REMARKS

Claims 25-48 are pending. Claim 48 has been objected to. Claims 25-48 have been rejected under 35 U.S.C. §112, second paragraph. Claims 25-48 have been rejected under 35 U.S.C. §103. Claims 25 and 48 have been amended. Support for the substantive amendments to claims 25 and 48 are found at least in claim 26. Claims 1-24 have been cancelled in previous correspondence. Claim 26 has been cancelled herein without prejudice. Claims 25 and 27-48 remain for consideration upon entry of the present Amendment. No new matter has been added.

Fig 3

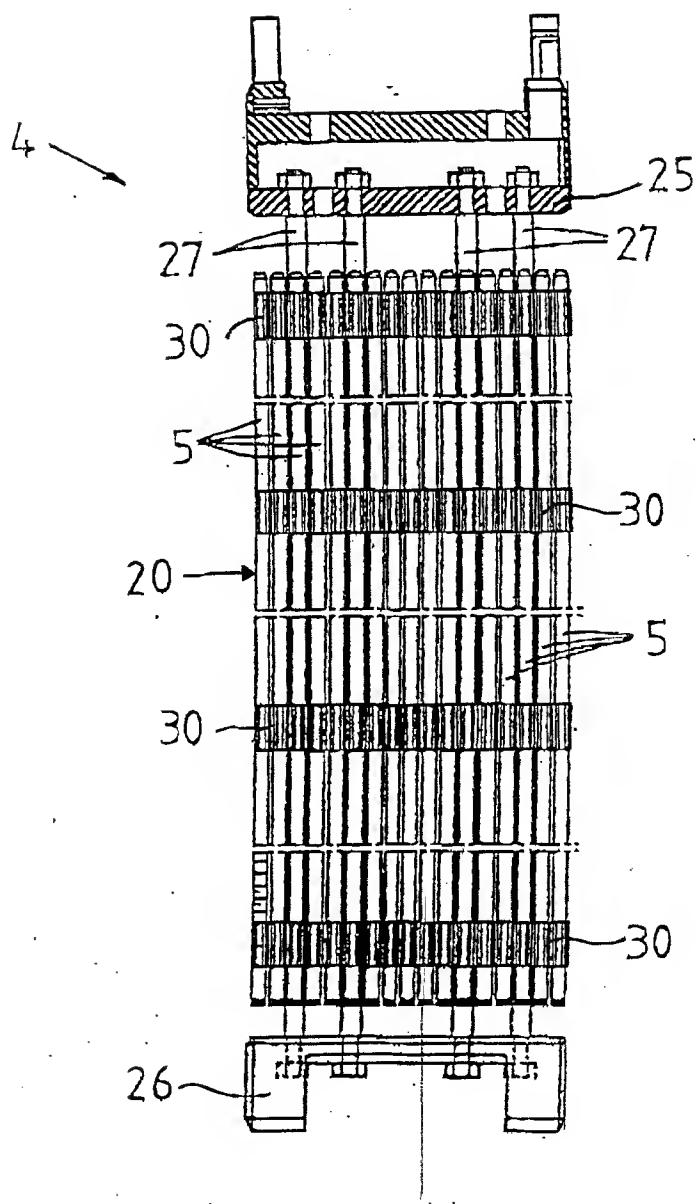
The Examiner has objected to the drawings as not showing every feature described within the specification and the relationships therein.

Applicants have reviewed the alleged informalities with regard to the drawings as pointed out by the Examiner and enclose Replacement Drawing Sheets for pages 3, 5, and 6 of the drawings. In these Replacement Sheets, reference numbers are added to indicate the upper edge 33, the lower edge 34, and the wave peaks 38 in Figures 6 and 8, and the fuel unit 20 in Figure 3. Accordingly, Applicants respectfully request that the Examiner withdrawn the objections to the drawings.
